HISTORIC AND DESIGN REVIEW COMMISSION

April 06, 2022

HDRC CASE NO: 2022-100
ADDRESS: 112 SOLEDAD ST
LEGAL DESCRIPTION: NCB 106 BLK LOT 8A
ZONING: D, H, RIO-3
CITY COUNCIL DIST.: 1
DISTRICT: Main/Military Plaza Historic District
LANDMARK: Individual Landmark
APPLICANT: Davis Sprinkle/sprinkle and co.
OWNER: david weider/112 SOLEDAD PARTNERS LLC
TYPE OF WORK: Conceptual approval of rear wall design and rear façade design
APPLICATION RECEIVED: March 18, 2022
60-DAY REVIEW: Not applicable due to City Council Emergency Orders
CASE MANAGER: Edward Hall

The applicant is requesting conceptual approval for the design of the rear river level wall and building façade at 112 Soledad.

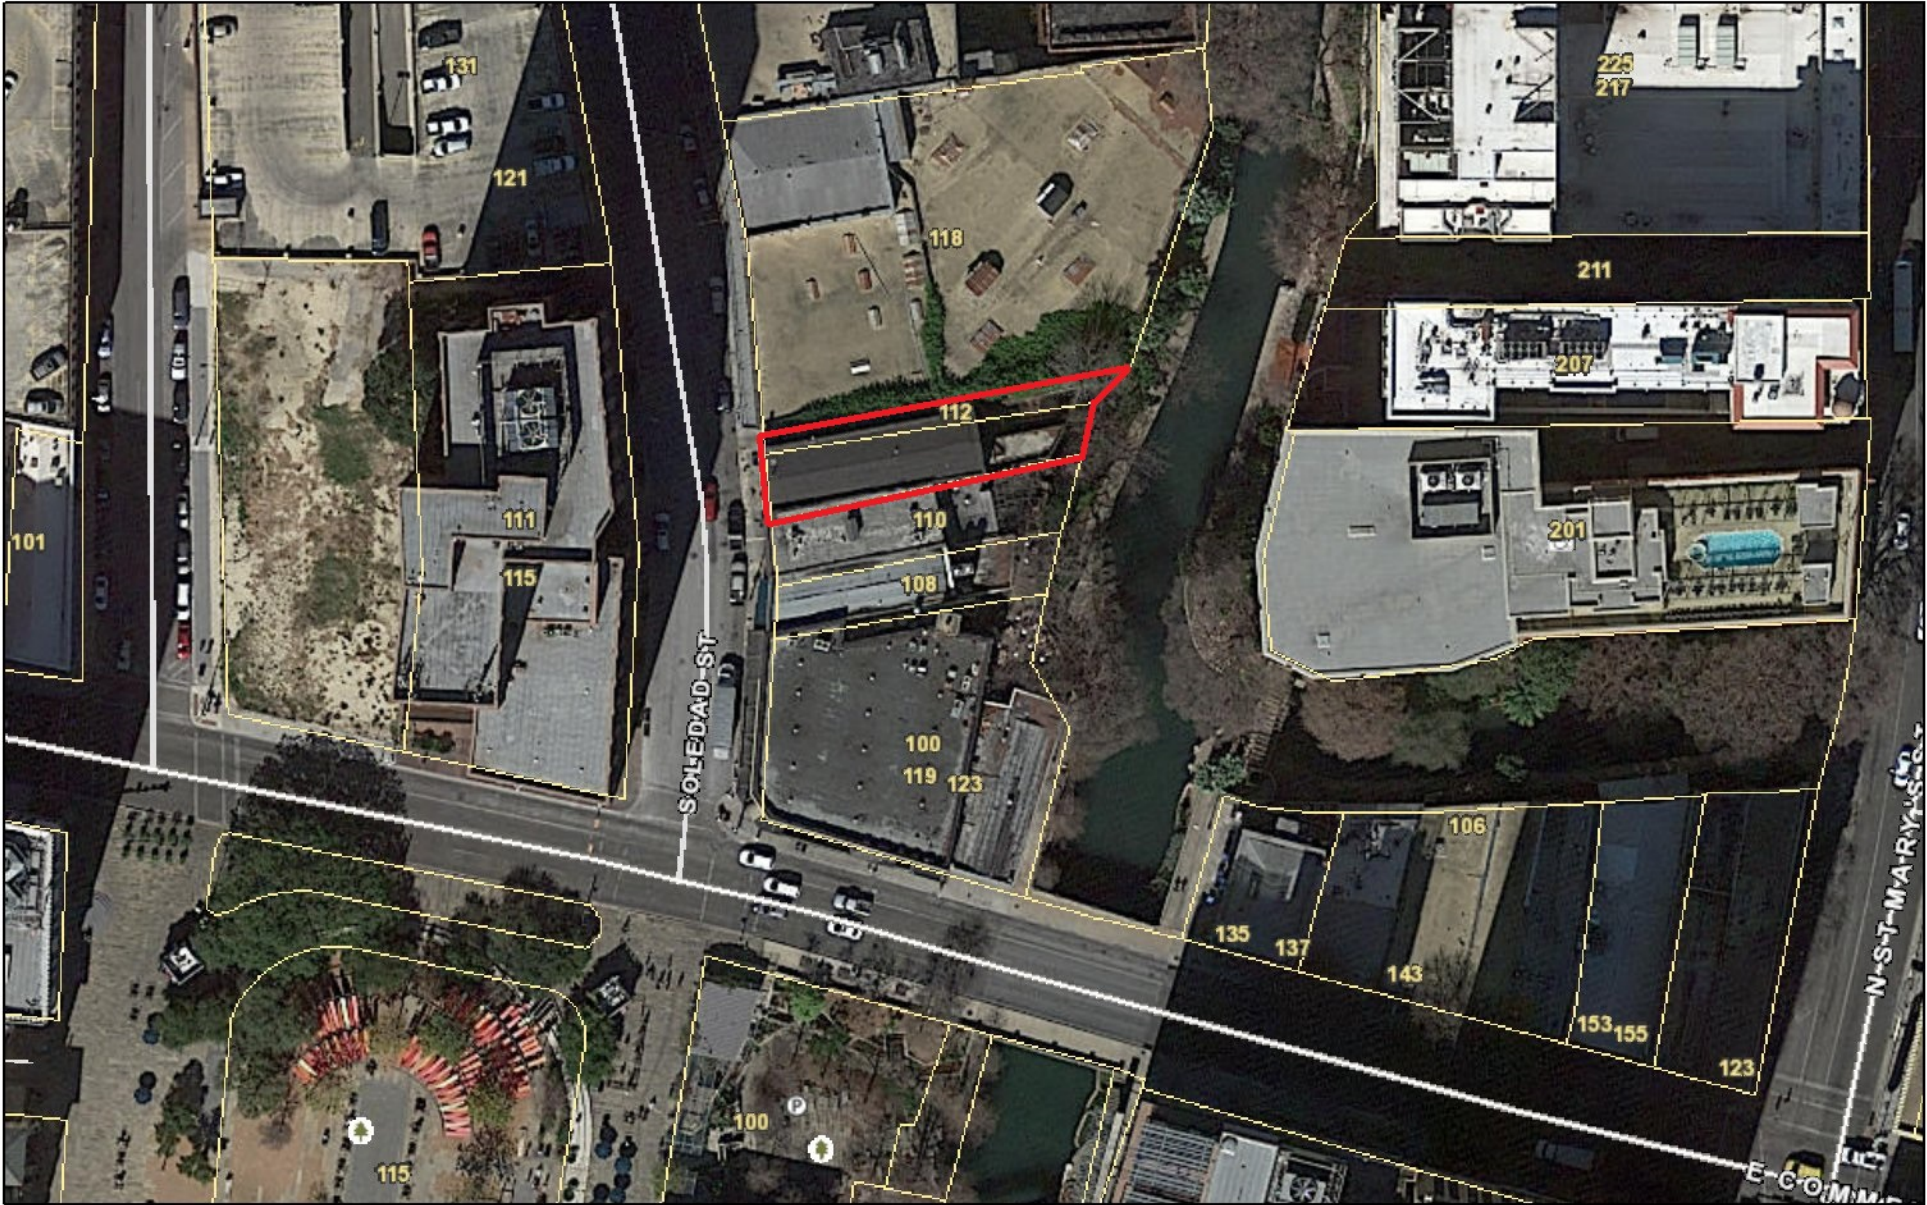
- e. **STONE WALL MODIFICATIONS** – Since conceptual approval in August 2021, the applicant has revised the design of the opening in the rear stone wall as well as the proposed rear elevation. Generally, staff finds the amendments to be appropriate. Staff finds that the applicant should provide documentation and a detailed plan for disassembly when returning to the Commission for final approval.

- f. **STONE WALL MODIFICATIONS** – When returning to the Commission for final approval, the applicant should have detailed construction documents of the rear stone wall, low stone walls and glass railing.

Staff recommends approval of the revised stone wall and rear façade based on findings a through h with the following stipulations:

- i. That the applicant provide documentation and a detailed plan for disassembly when returning to the Commission for final approval.
- ii. The applicant provide detailed construction documents of the rear stone wall, low stone walls and glass railing when returning to the Commission for final approval.
- iii. That coordination with Center City Development and Operations Department continue regarding all lease agreements and site modifications.
- iv. ARCHAEOLOGY – An archaeological investigation is required. The project shall comply with all federal, state, and local laws, rules, and regulations regarding archaeology, as applicable.

112 SOLEDAD - RIVER LEVEL

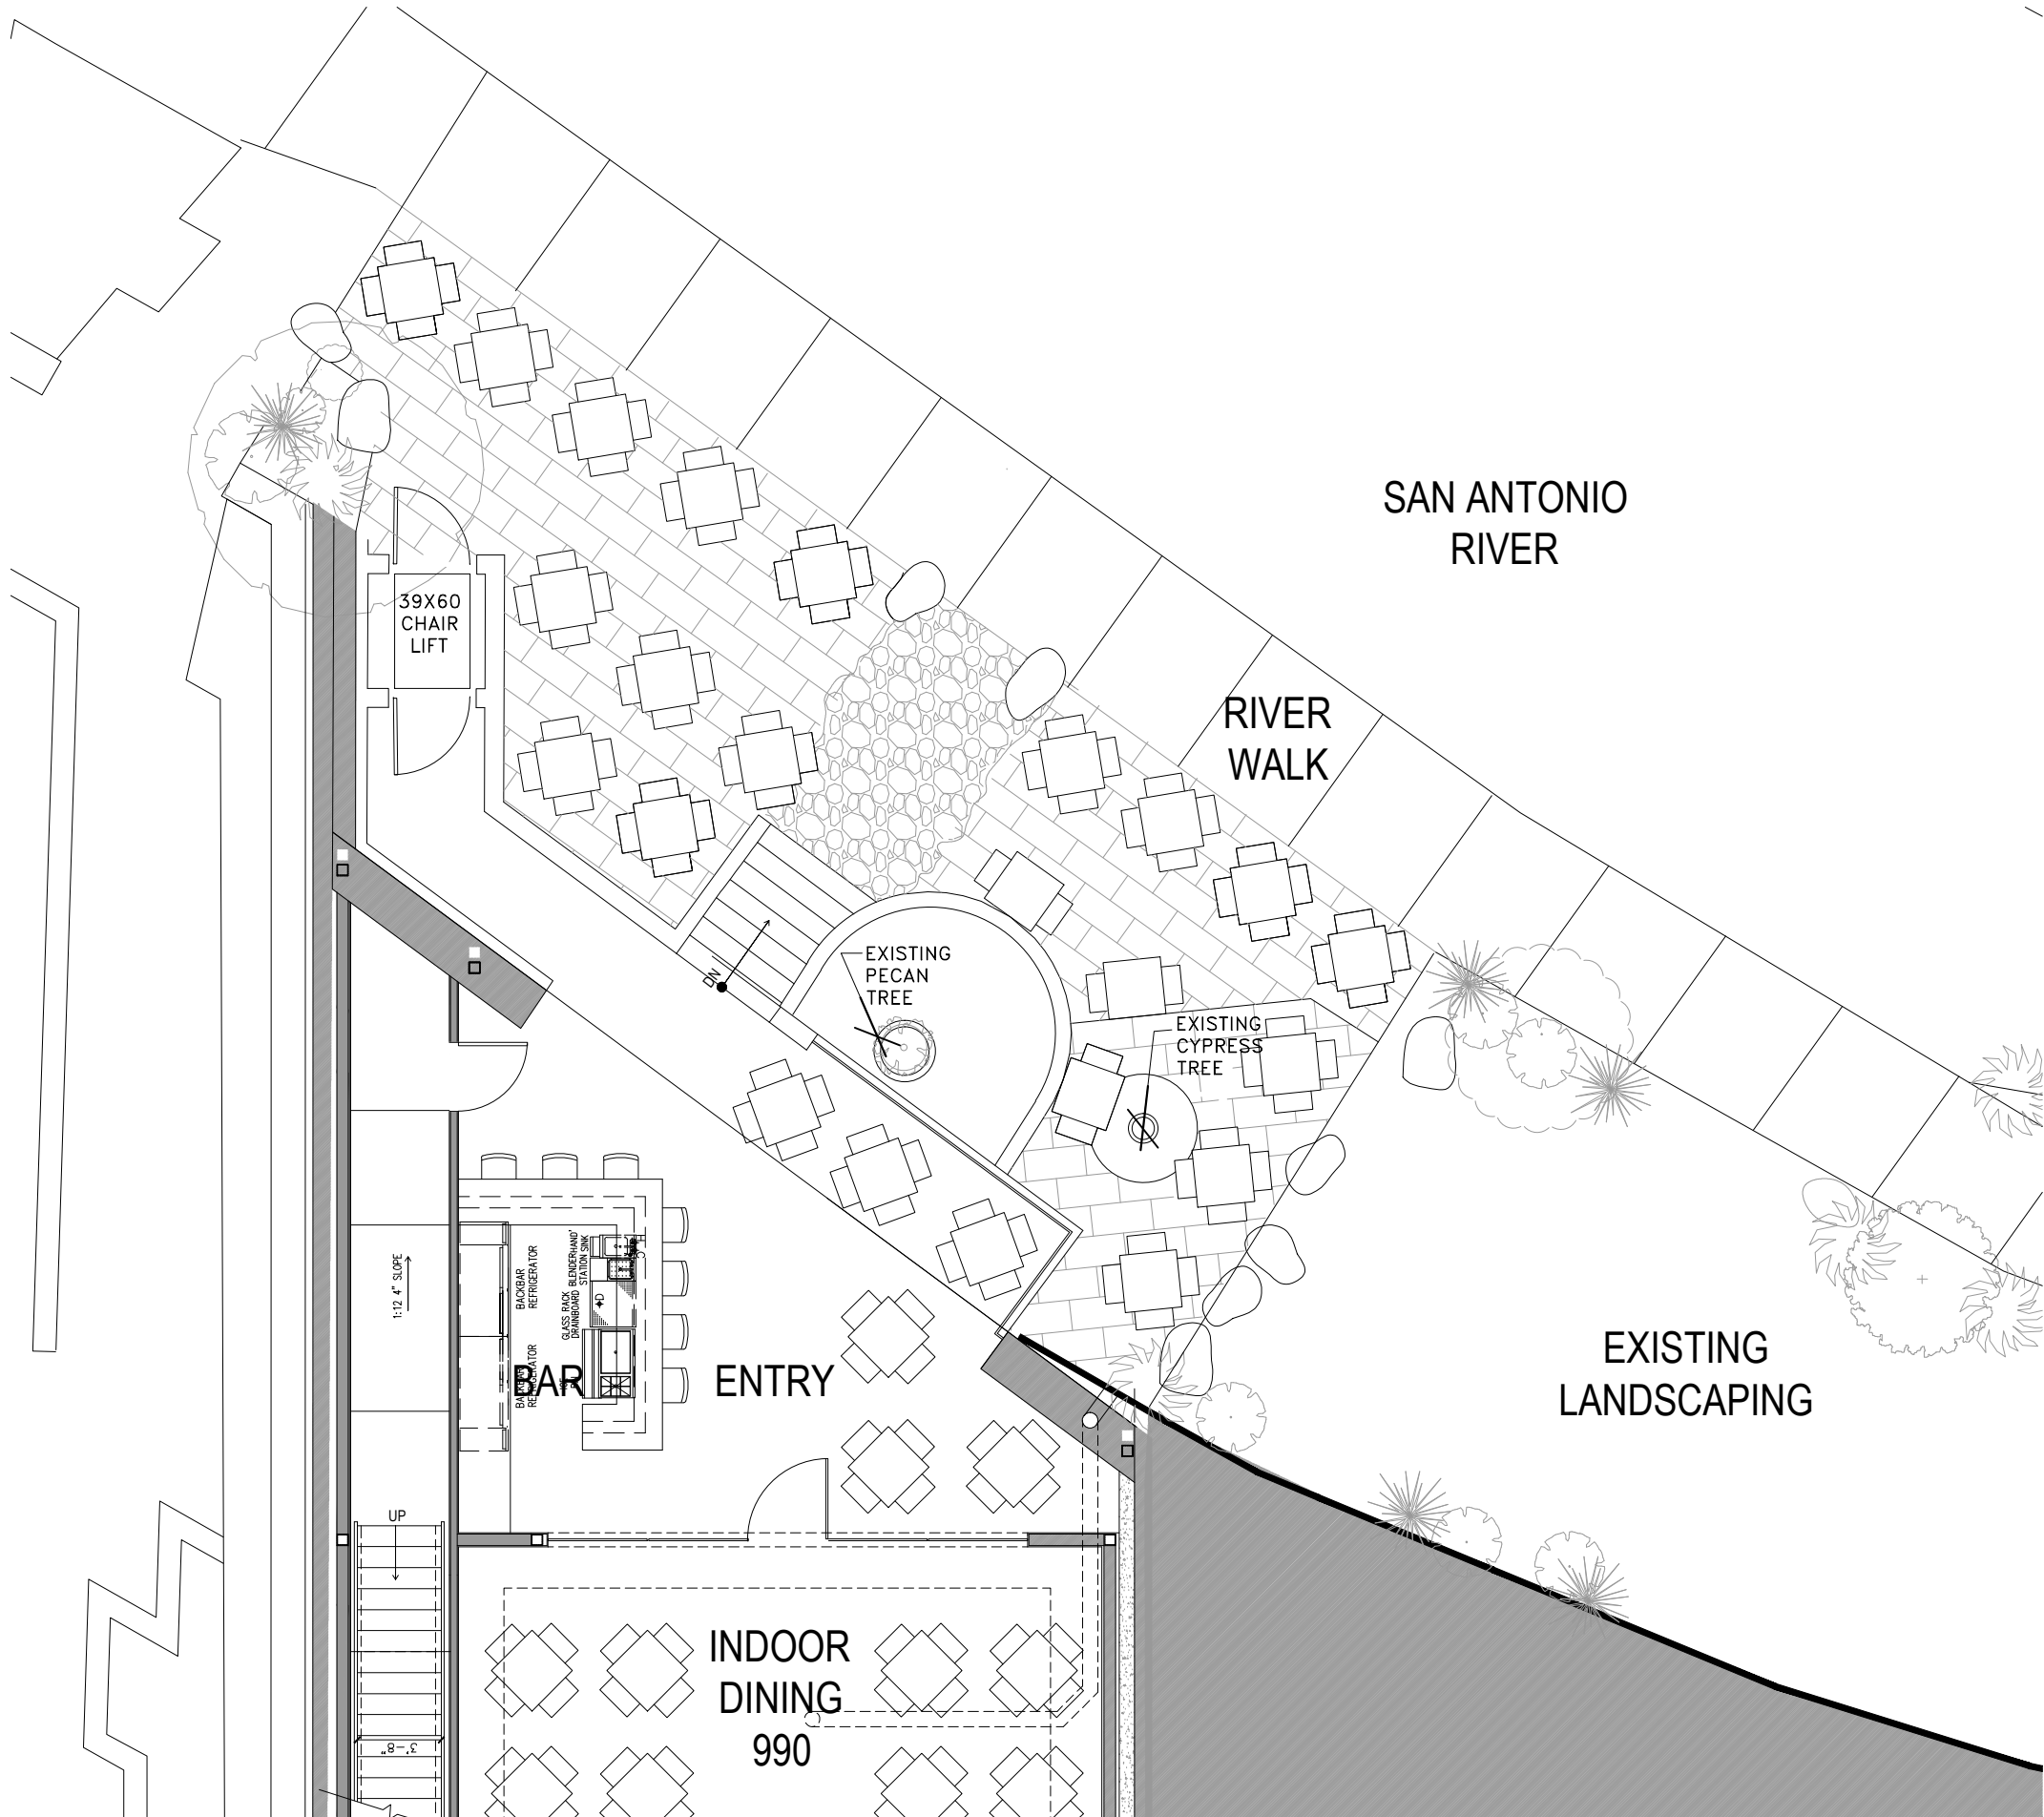
- a. The applicant is requesting conceptual approval for the design of the rear river level wall, building façade and patio design at 112 Soledad.
- b. **CONCEPTUAL APPROVAL** – This request received conceptual approval from the Historic and Design Review Commission on August 18, 2021, along with both a rooftop and rear addition and rehabilitation. River level and wall modifications received approval with the following stipulations:

- i. That as the design of the rear façade and patio progresses that the applicant should provide documentation and a detailed plan for disassembly, on site storage and reassembly as part of the incorporated design and that the wall be reconstructed in a manner that features smaller, punched wall openings which generally maintains the historic appearance of the wall.
